APPEAL SUMMARY

Appeal ID: 20392	Project Address: 2306 SE Caruthers St
Hearing Date: 5/15/19	Appellant Name: Daniel W. Keller
Case No.: B-003	Appellant Phone: 225-244-5900
Appeal Type: Building	Plans Examiner/Inspector: Preliminary
Project Type: residential	Stories: 2 Occupancy: R-3 Construction Type: V-B
Building/Business Name:	Fire Sprinklers: Yes -
Appeal Involves: Alteration of an existing structure	LUR or Permit Application No.:
Plan Submitted Option: pdf [File 1] [File 2] [File 3] Proposed use: ADU

Samuelson Garage Studio
#2306 SE CARUTHERS RD

1 Section, Existing & New, (E-W)
A3.0 Scale: 3/8" = 1'

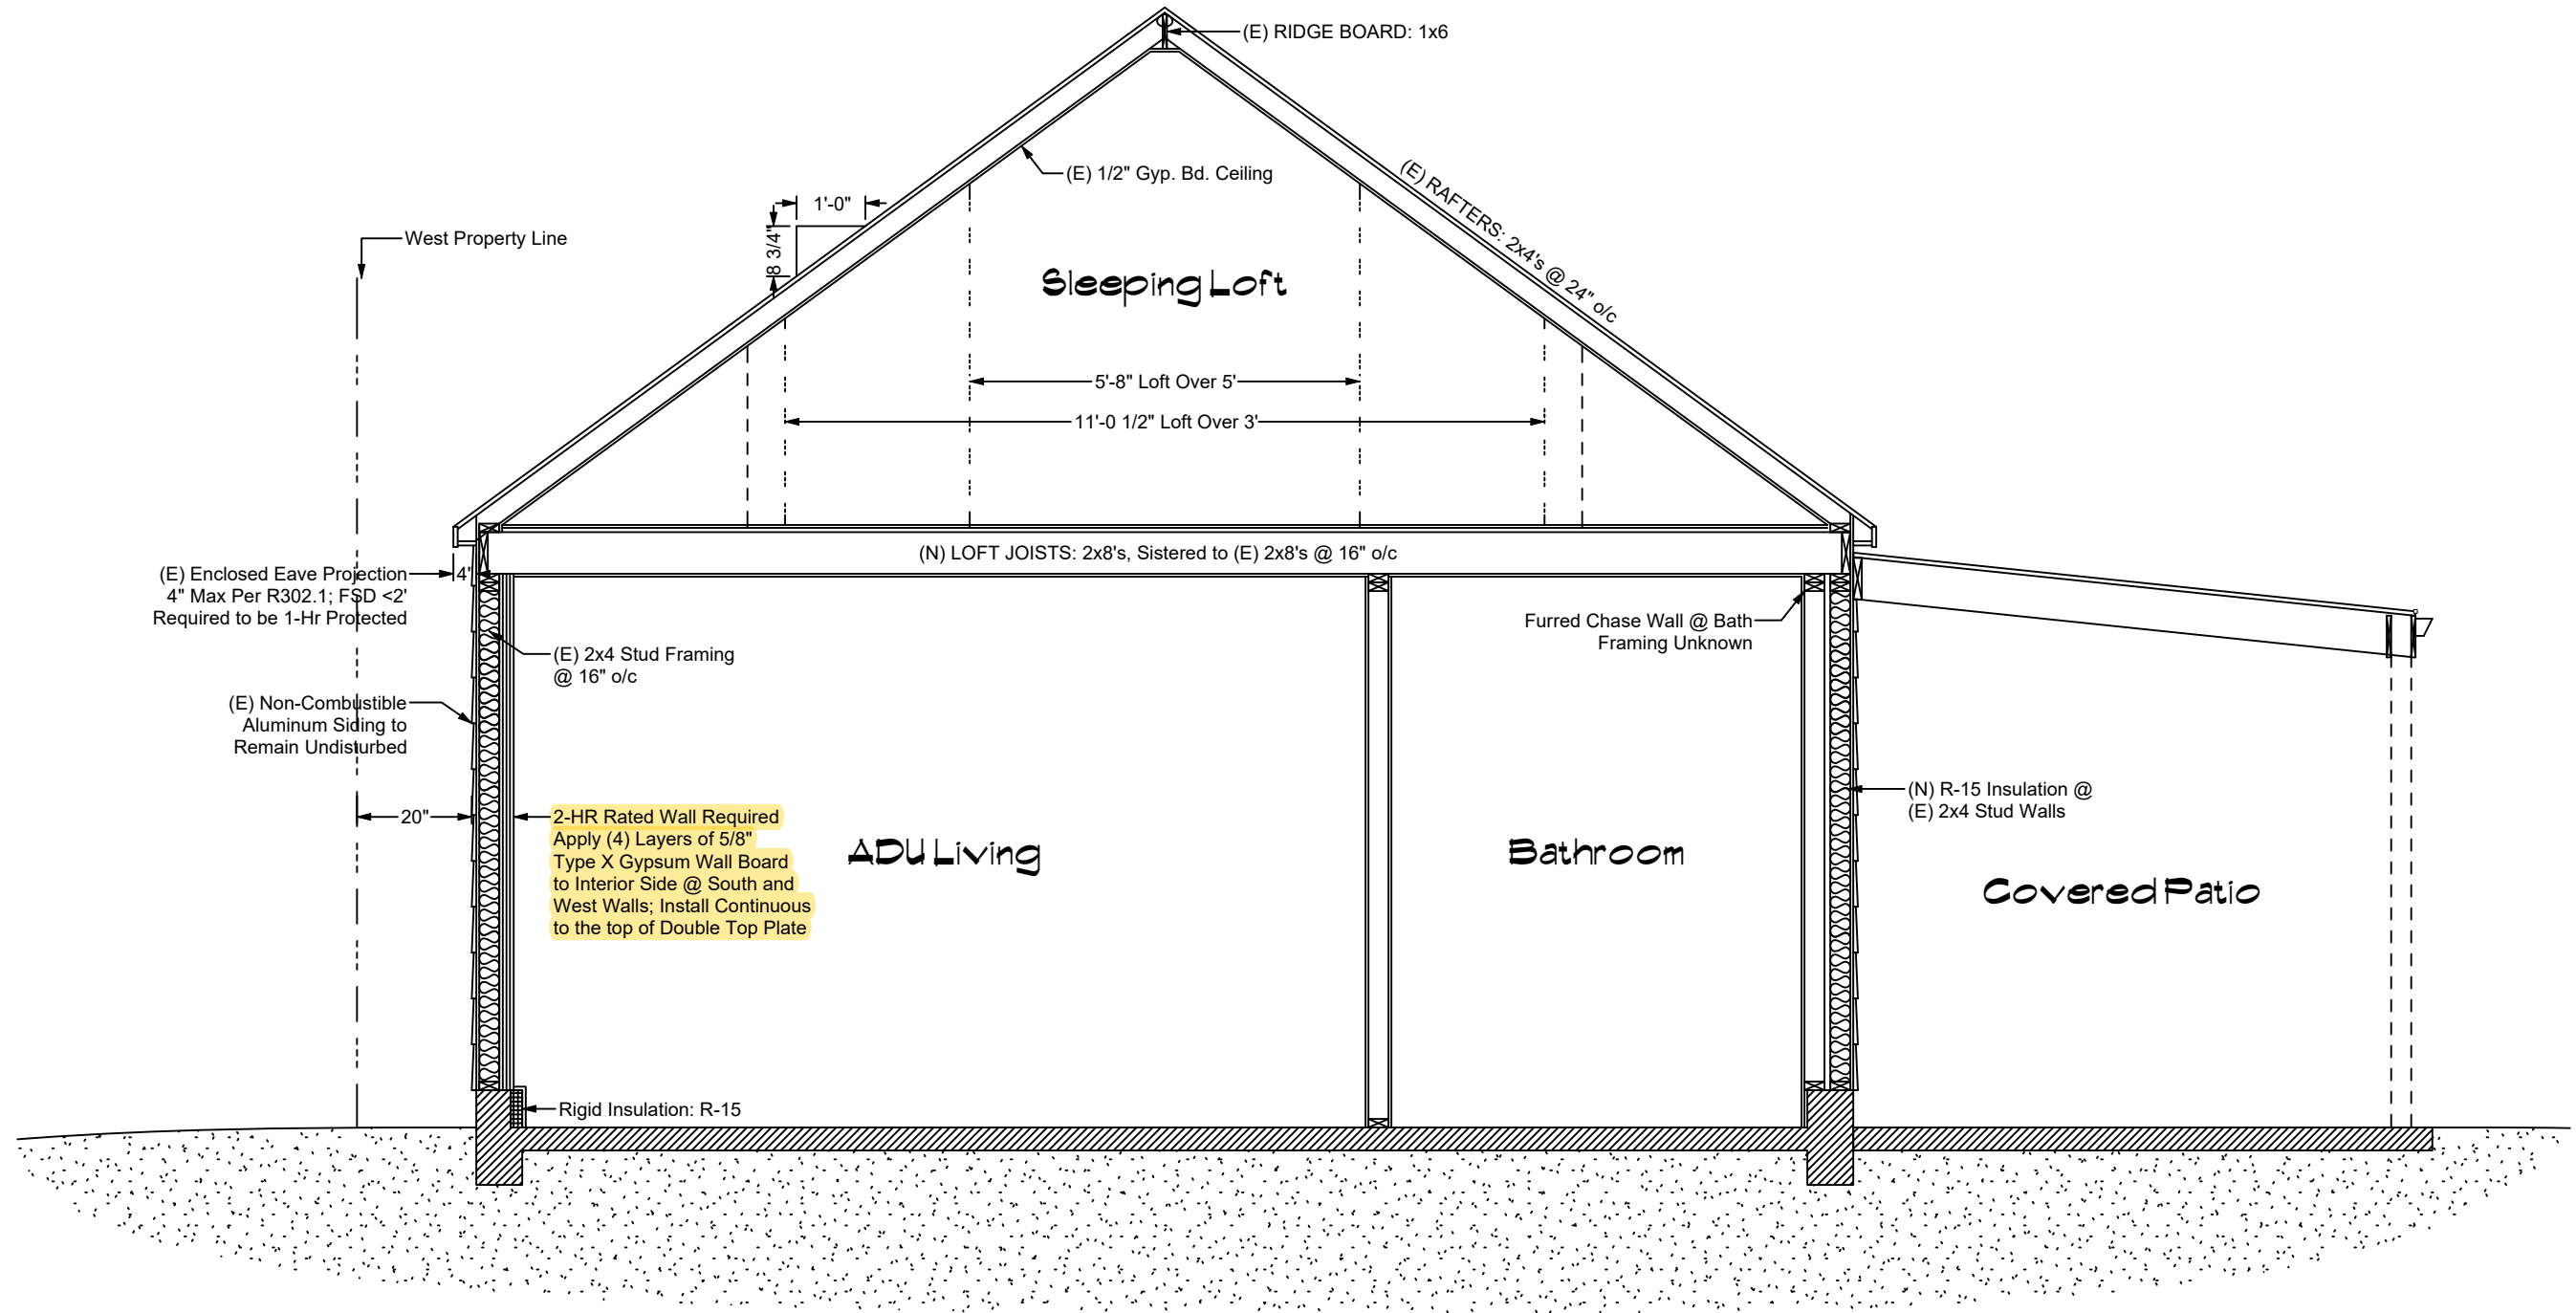
Requires	Code requires 2 hour-tested in accordance with ASTM E 119 or UL 263 with exposure from both sides, and; Exterior wall covering with a flame spread index of 25 or less as determined in accordance with ASTM E 84 or UL 723, or approved equivalent for walls less than 3' from property line in dwelling units containing a loft.
Proposed Design	<p>The proposal is to convert an existing detached garage into an ADU. The garage is located 20" from the South and West property lines. The existing garage is finished at the exterior face with aluminum siding in conformance with ASTM E 84. The proposed alternative method is to leave the exterior membrane undisturbed and meet the required 2-hr fire rating by applying (2) additional layers of 5/8" Type X Gypsum on the interior side only. The referenced assembly UL-U301 contains the following specifications:</p> <p>Base Layer: 5/8" (15.9 mm) ToughRock® Fireguard X™ or 5/8" (15.9 mm) DensArmor Plus® Fireguard® gypsum board applied vertically or horizontally using 1-7/8" (48 mm) 6d coated nails 6" (152 mm) o.c. to each side of 2" x 4" wood studs 16" (406 mm) o.c. Face Layer: 5/8" (15.9 mm) ToughRock® Fireguard X™ Products or 5/8" (15.9 mm) DensArmor Plus Fireguard gypsum board applied vertically or horizontally to studs over base layer with 2-3/8" (60 mm) 8d coated nails 8" (203 mm) o.c. Stagger joints 16" (406 mm) o.c. each layer and side. Sound Tested with studs 16" (406 mm) o.c. and with nails for base layer spaced 6" (152 mm) o.c.</p> <p>The alternative would alter sections indicating "to each side" to "to interior side only."</p>

Reason for alternative	<p>The alternative is requested because the garage is finished in an existing original non-combustible exterior aluminum siding is desired to be left undisturbed.</p> <p>The reason will provide equivalent fire protection as the exterior wall covering is of non-combustible metal siding, the interior side will be provided with required layers of fire rated gypsum wall board, and the structure will be equipped with an automatic sprinkler system.</p>
-------------------------------	--

- 1. Unprotected openings in walls within 3 feet of property line. Denied. Proposal does not provide equivalent Life Safety protection.**
- 2. Alternate 2 hour exterior wall assembly: Denied. Proposal does not provide equivalent Life Safety protection.**

2 Elevation, (E) & (N), West
A4.0 Scale: 3/16" = 1' 0' 2' 4'

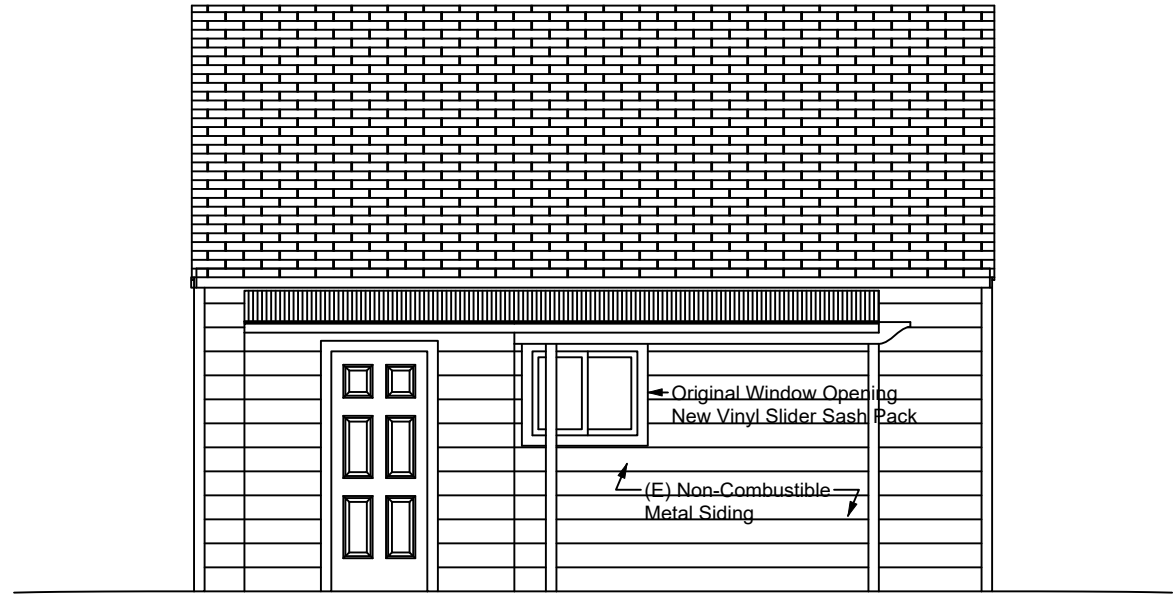
Proposed Design The proposal is to convert an existing detached garage into an ADU. The garage is located 20" from the South and West property lines. We are proposing to maintain the existing original [35"x28"] opening on the West Facade and the existing original [35"x28"] and [35"x46"] openings on the South Facade. As the unit contains a loft, the walls will be 2-hr fire resistance rated assemblies and the building will be equipped with an NFPA 13D fire sprinkler system per R329.3.

The openings are an existing original condition of the garage, and;
The intent of the proposal is to convert an existing non-habitable space to living space. In doing so, we are required to meet the standards set forth in R303 for Habitable Rooms. Currently, the existing window configuration meets and exceeds the standards set forth in this section. To cap the three openings in question would take the structure out of conformance with R303, and thus maintaining the openings as-built will provide better health standard for the ADU.
Furthermore, the alternative will provide equivalent fire protection as the walls assemblies will be updated to meet the required 2-hr fire rating and the building will be provided with additional fire resistance via an NFPA 13D fire sprinkler system.
